REPAIR REQUEST LIST

1234 Main St.
04/06/2022 1:51 pm

7.2.1 - Bathrooms: Sinks, Tubs & Showers
DAMAGED CAULK IN SHOWER

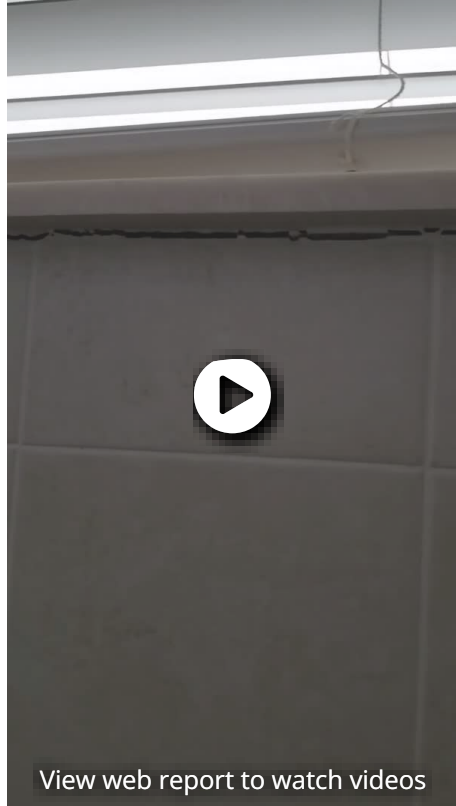
I observed damaged/separated caulk and in the bathroom shower. Windowsill has curved and pulled away from tile leaving gap in caulk. This could allow moisture to get behind tiles. Recommend further evaluation and repair from a qualified professional.

\$600 credit requested

Credit requested for further evaluation and repair.

7.2.2 - Bathrooms: Sinks, Tubs & Showers
REDUCED WATER PRESSURE

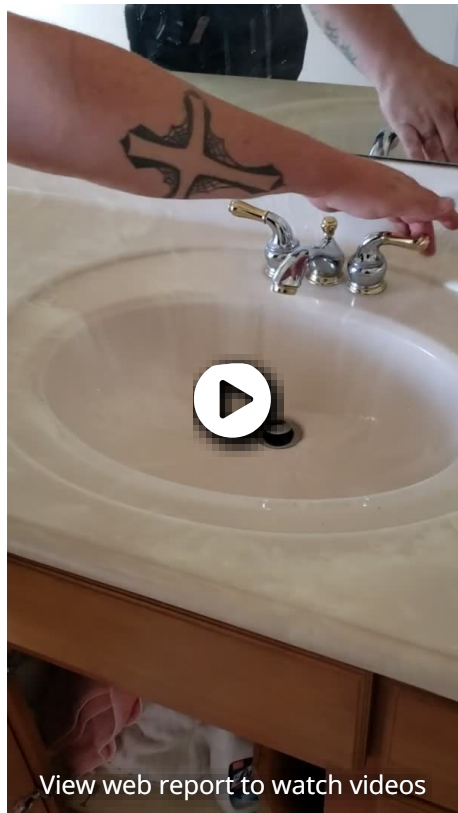
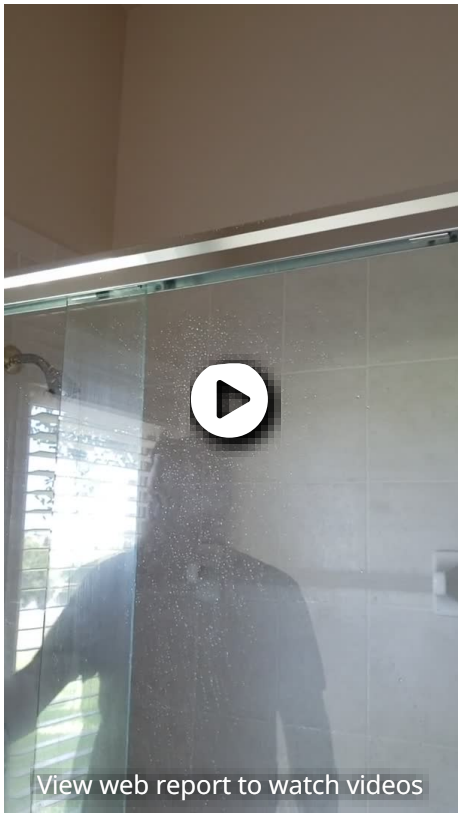
I observed the water pressure in Bathroom 2 (left rear of home), the pressure was low with both faucet handles to the full open position. The shower also had low water pressure and was spraying outside of the shower door. In need of correction.

\$400 credit requested

Credit requested for evaluation and correction by plumber.
